700 NE 45TH ST APARTMENT BUILDING

700 NE 45th St Apartment Building
3041176-EG, 3041273-LU

Design Recommendation
05.13.2024

8.0 ITEMIZED RESPONSE TO EDG

View West - Relationship of Proposed Building and North Neighbor

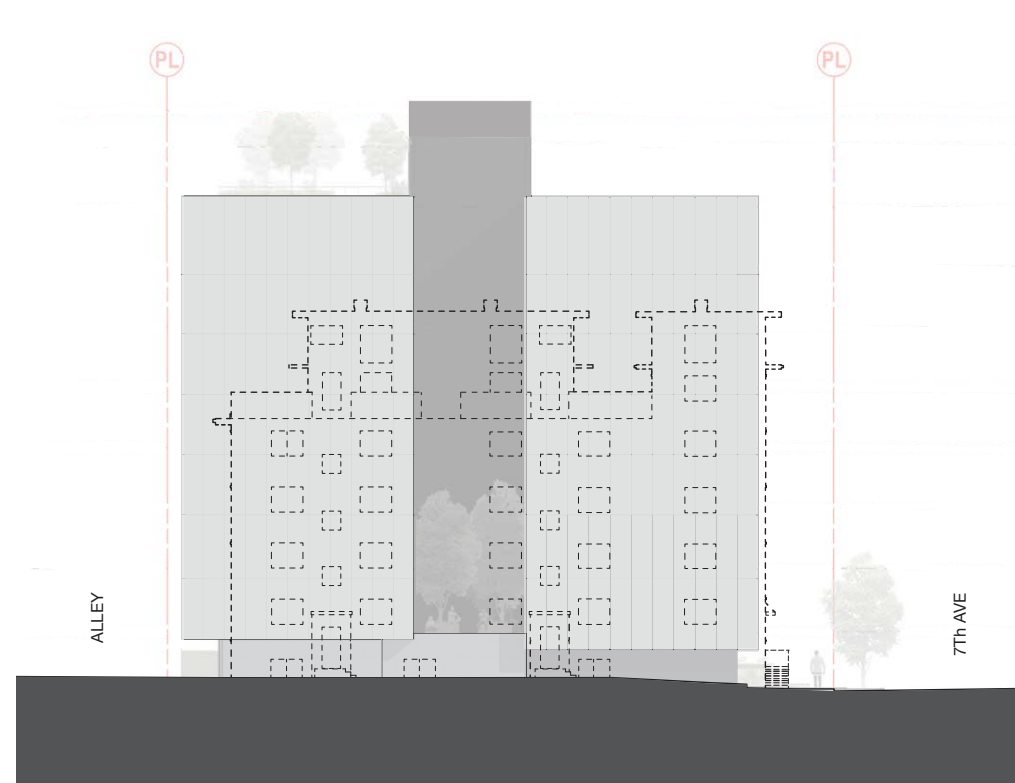
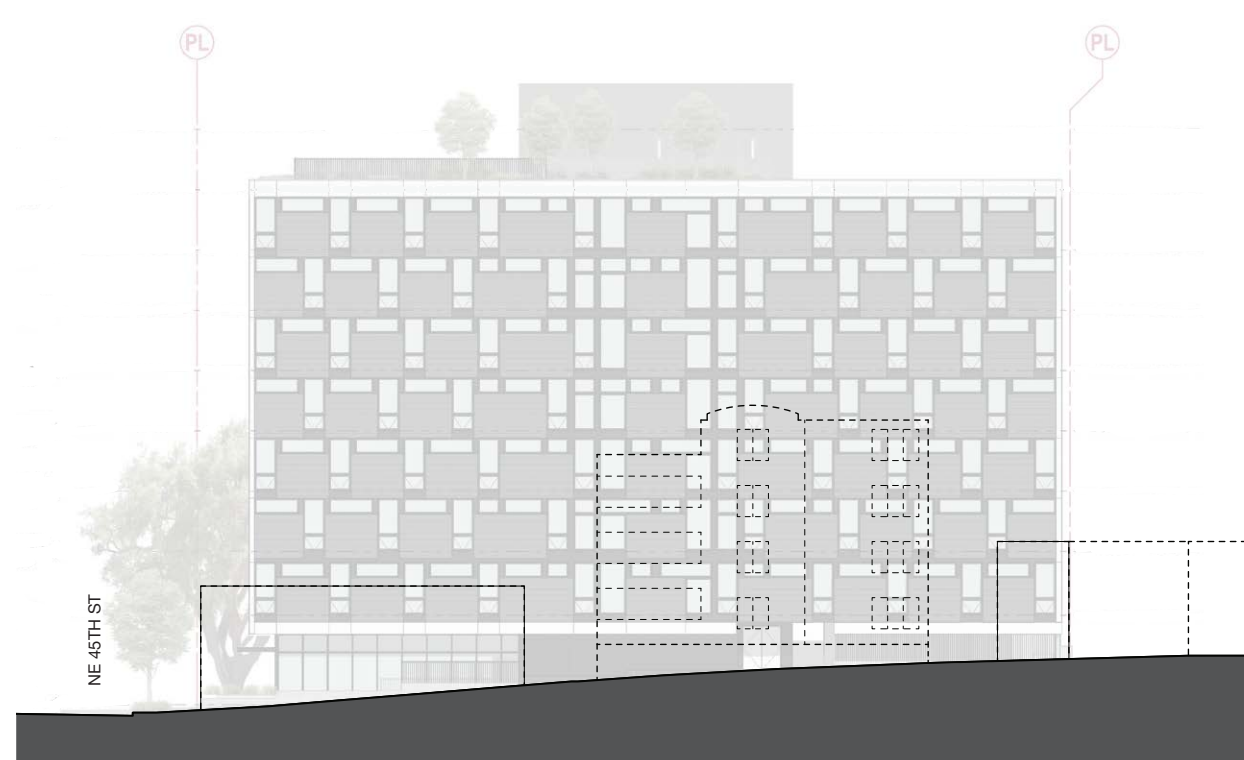
c) The Board requested more specific information be provided in the Recommendation packet, describing how the Concept 3 design relates to the adjacent sites to the north and east, including window locations and programing at the ground level. (CS2-D-5)

A courtyard is introduced at the north elevation to provides relief to the neighboring building and minimize shading. The courtyard also orients apartment units away from the neighboring building, providing a greater degree of privacy. No windows from the proposed building face the north.

On the east façade, a mixture of clerestory and full height windows are used to minimize concerns for privacy of eastern neighbors. The roof top terrace is located towards the south to provide greatest separation between the terrace and neighboring residential units.

Additional shadow created by structure

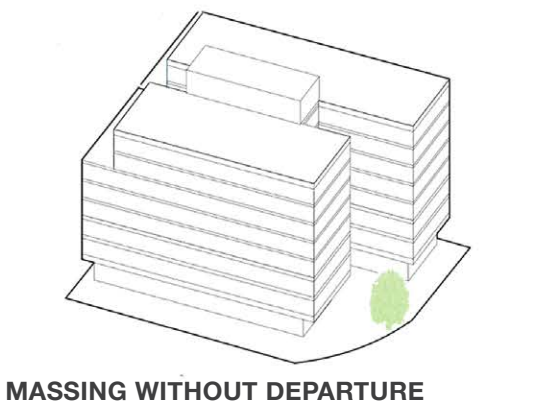
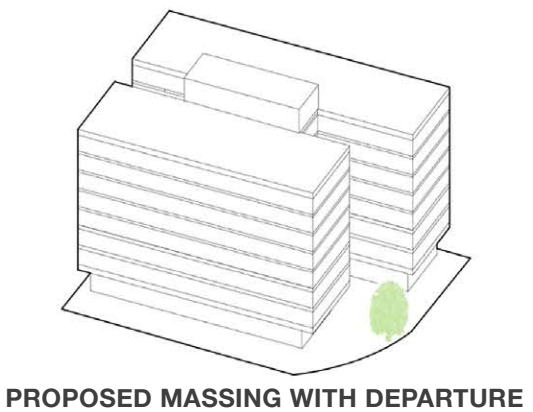
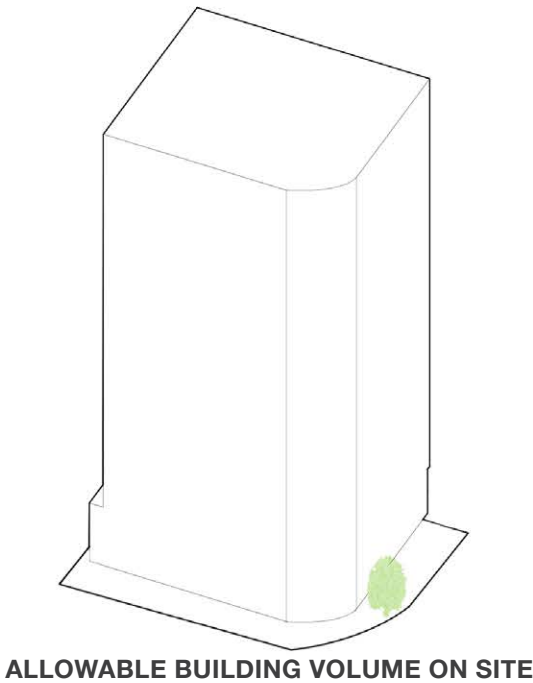
d) The Board supported Concept 3's shift in massing to the north that allows for the preservation of the Heritage Tree, but they noted that additional information in the Recommendation packet would be useful to understand the design impact of the reduced upper-level setback on natural light to the adjacent building to the north. (CS1-1-a, CS1-B-2)

The additional mass within the 15ft setback above 65ft has limited impact in the shading of the north neighbor as shown in the comparative shade diagrams. A centrally located courtyard along the north façade helps minimize the shading impacts to the adjacent building.

The proposed midrise 8-story project is significantly smaller in scale than the allowable maximum building height for the site. The new proposed project would have far less impact to neighbors natural light with a proposed total height less than half that of the maximum highrise building height .

The project would also lose 16 bedrooms without the departure.

Revised South Elevation

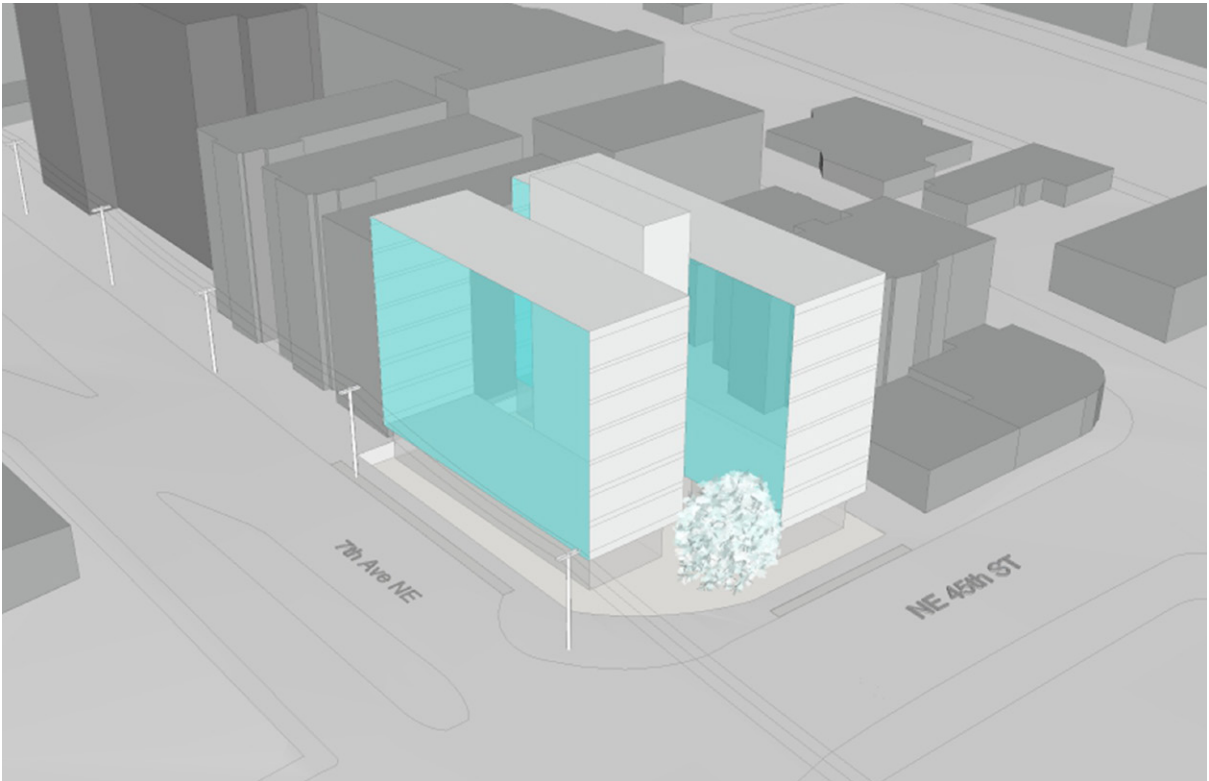
a) The Board requested additional study of the blank façade at the south elevations shown on page 48 of the EDG packet, noting that this is a prominent façade that will be visible from many vantage points. The Board suggested evaluating additional windows, glazing, different materials, secondary massing moves, and artwork, to showcase this as a gateway to the U-District, while also keeping the interior programming in mind. (DC2-2-g, DC2-2-l, DC2-B-1, DC2-B-2)

The design team took the recommendation of the board at EDG and studied multiple iterations of the south façade. The current proposal introduces a wrapper shielding residents from the neighbor to the north and busy street / intersection to the south, while introducing selective slot and clerestory windows to the south facade facing busy NE 45th St. This fenestration patterning echoes that of the east and west facades, while maintaining privacy for the unit bedrooms facing NE 45th St.

The team also differentiated the material at the core from that of the adjacent east and west legs of the building. The change in material further breaks up the overall building mass, reducing the perceived bulk and scale of the building.

Section A

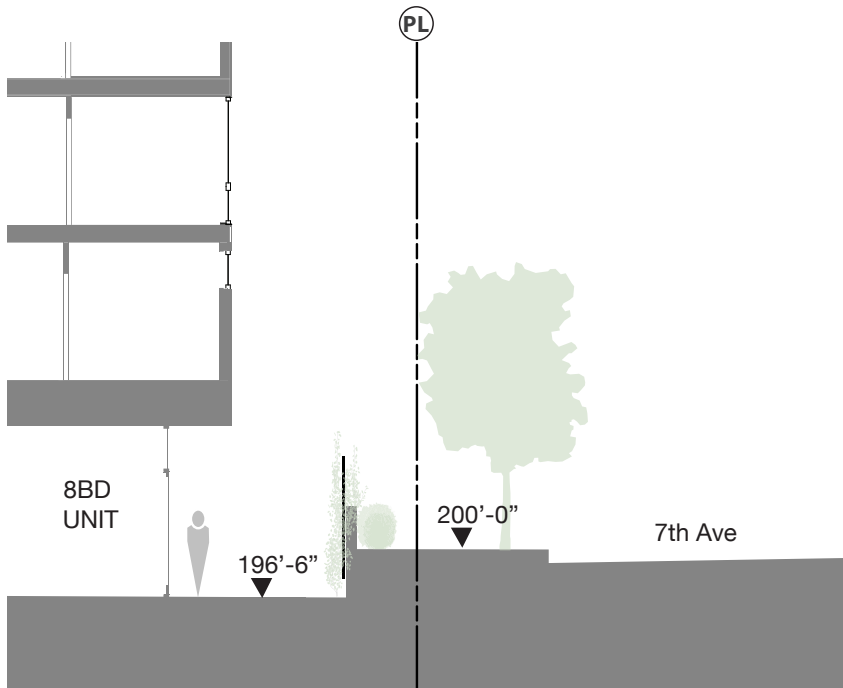
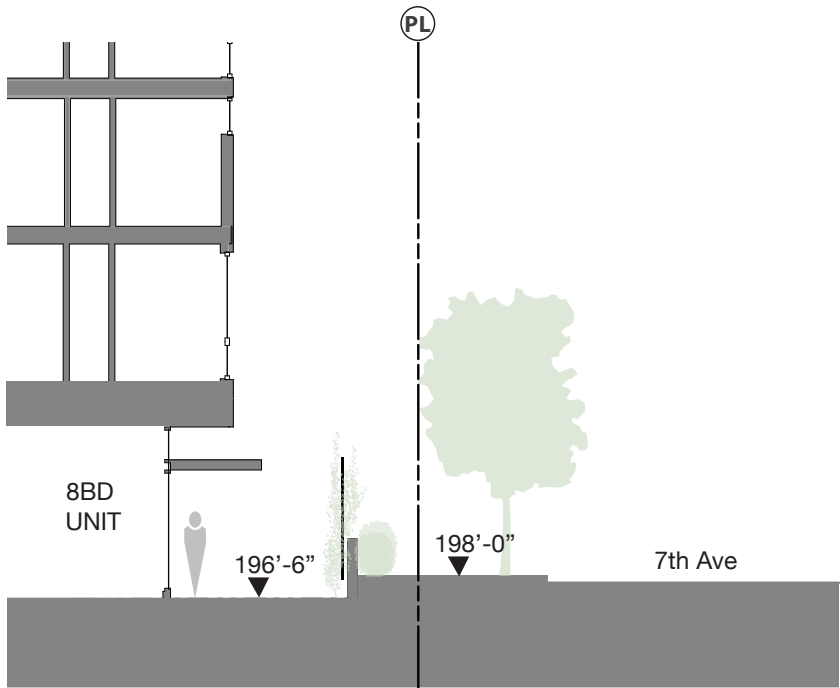
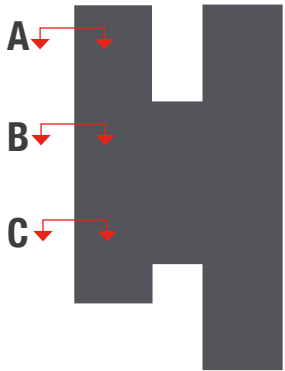
a) The Board expressed concern regarding the integration of the building with the street level, particularly the sidewalk's relationship to the lower-level residential spaces. The Board requested information in the Recommendation packet that clearly demonstrates the building's relationship with 7th Avenue, adjacent buildings, and the route for cyclists. (PL3-2, CS2-B, CS2-2)

c. The Board requested cross-section drawings at 7th Ave NE, to help visualize the transition from the public sidewalk area to the residential units. (PL3-2-c)

The largest differential between the sidewalk grade and terrace at the northern corner of the site is 4'-11". Plantings on both the street and terrace side of the retaining wall help to mitigate the change in elevation as well as provide privacy to lower level units.

Landscape Site Plan at Street Level

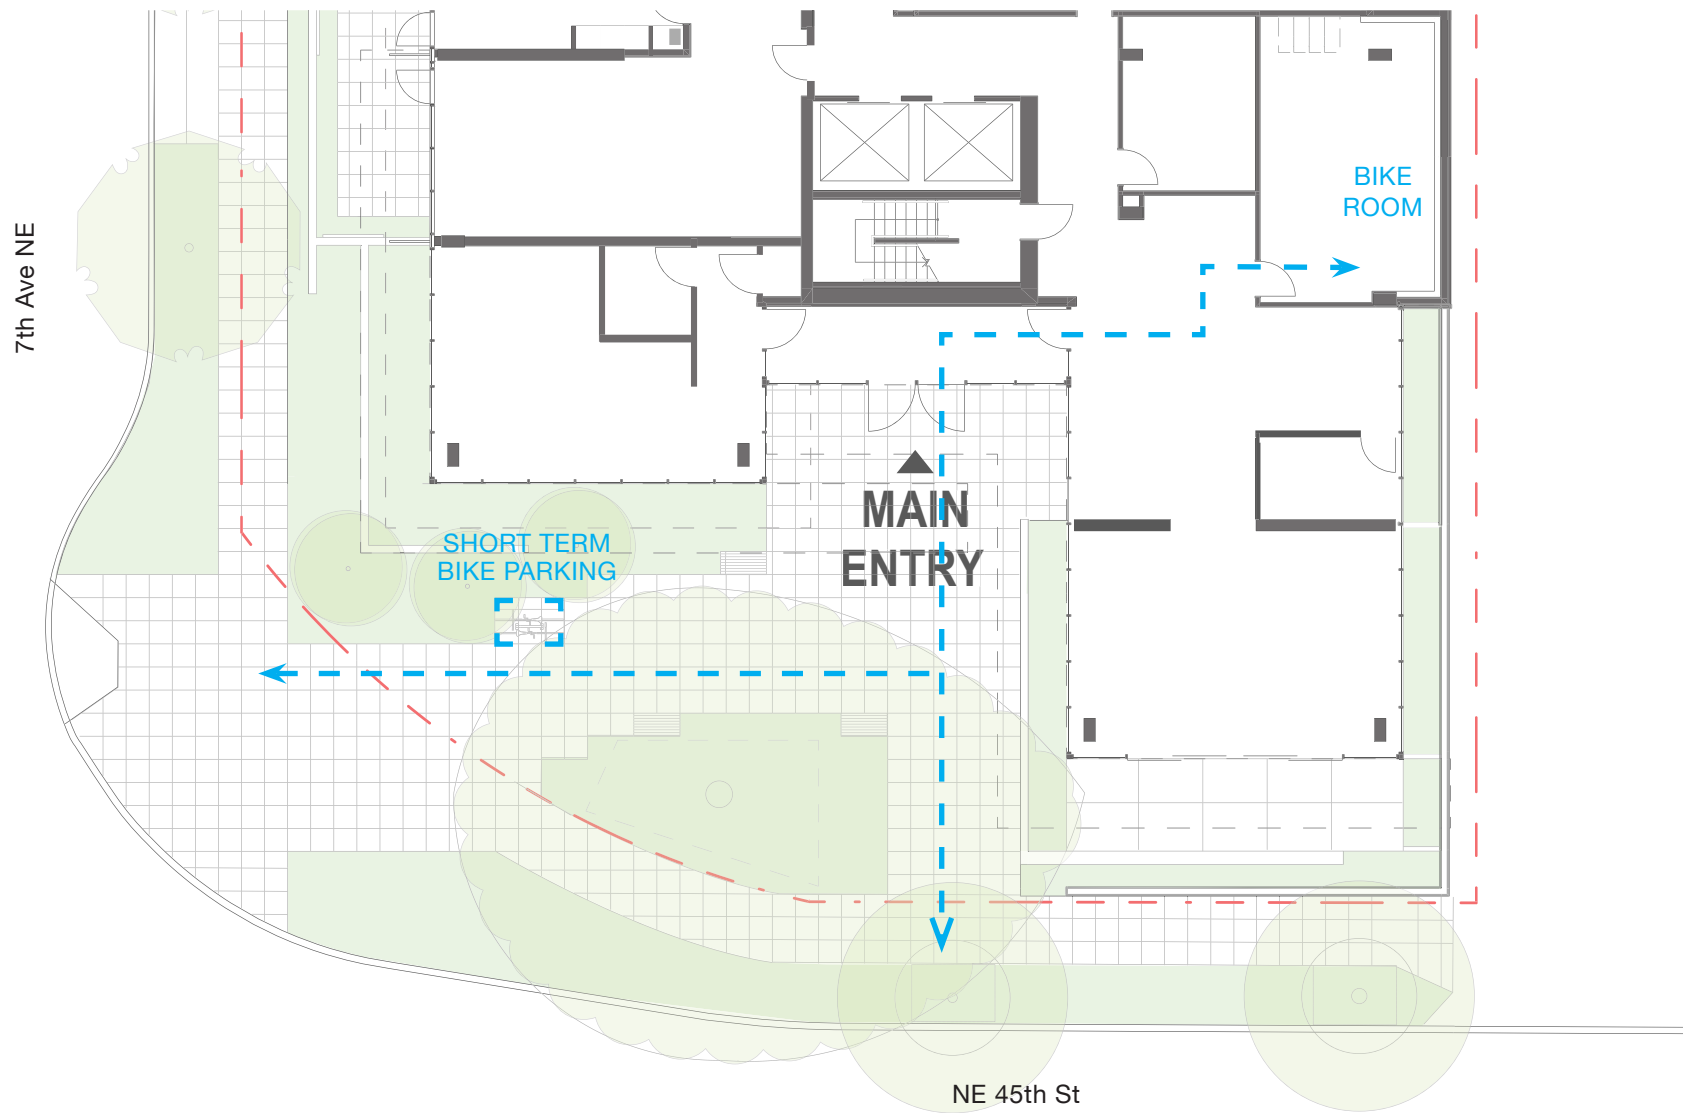
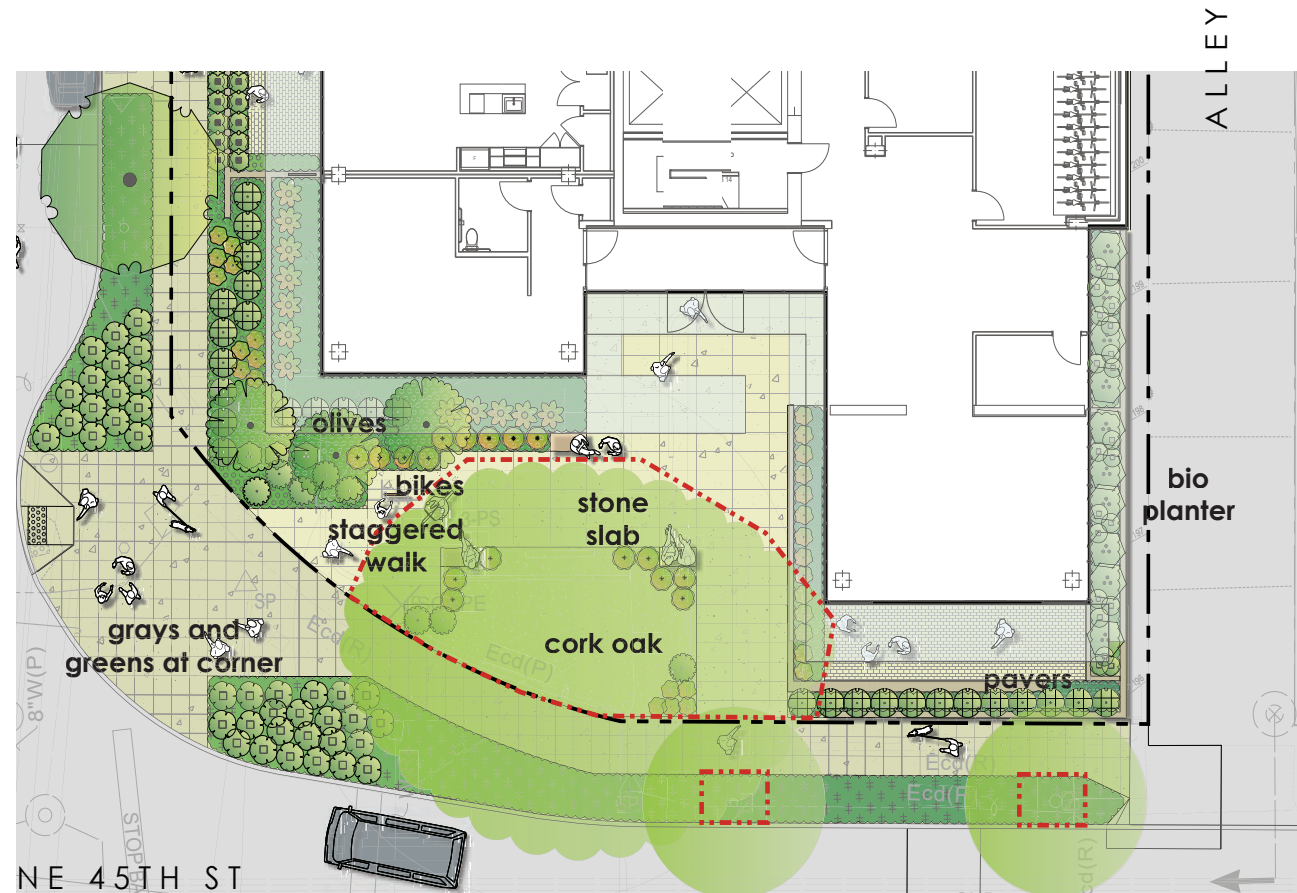
b) The Board requested complete details on the bike route between the street and the building, including whether bikes will use the main entry. (PL4-1-c, PL4-B-1)

Long term bike storage is provided on the first floor adjacent to the lobby space. Bicycles will enter the site off of NE 45th st and will use the main entry to the building to access the bike storage.

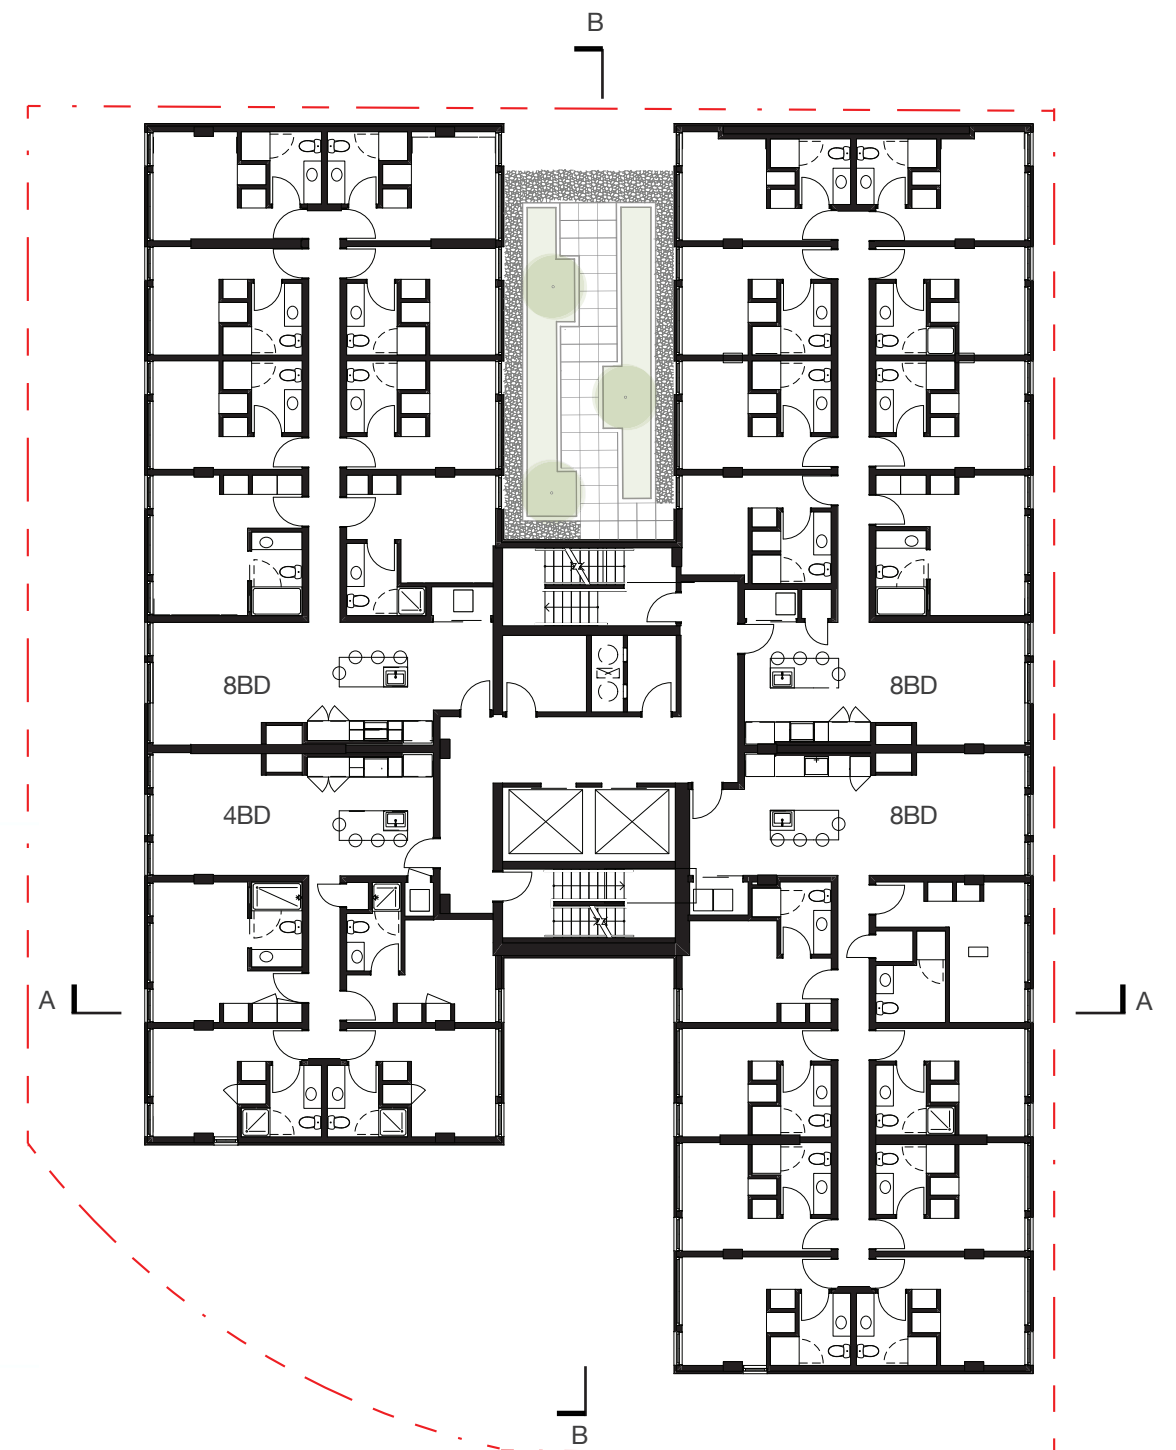
d) The Board encouraged extensive plantings to create a full-feeling landscape at the southwest corner, as opposed to below-grade or "sunken down" plantings, in order to increase visibility from the sidewalk or street. (DC4-D-4)

e) Overall, the Board emphasized the importance of landscaping and site design that contribute positively to the area's visual appeal and functional usability. (PL 1, DC3, CS2-B, CS2-2)

Planting areas at the southwest corner have been extended and expanded in area since the EDG meeting, with colorful grey/green fragrant flowers and foliage wrapping both sides of the corner, leading into the extensive plantings and paving wrapping the Cork Oak.

The extensive entry terrace provides a variety of spaces for connections at the corner. Along 7th Avenue a pedestrian easement now permits a standard landscape strip at the curb, as well as a landscape strip at the base of the fence line. The layering permits softening of this public edge, with a mix of plantings at the fence.

Similarly, the planter along the south property line and the bioplanter along the active alley provides a layer of landscape that softens this well used public frontage.
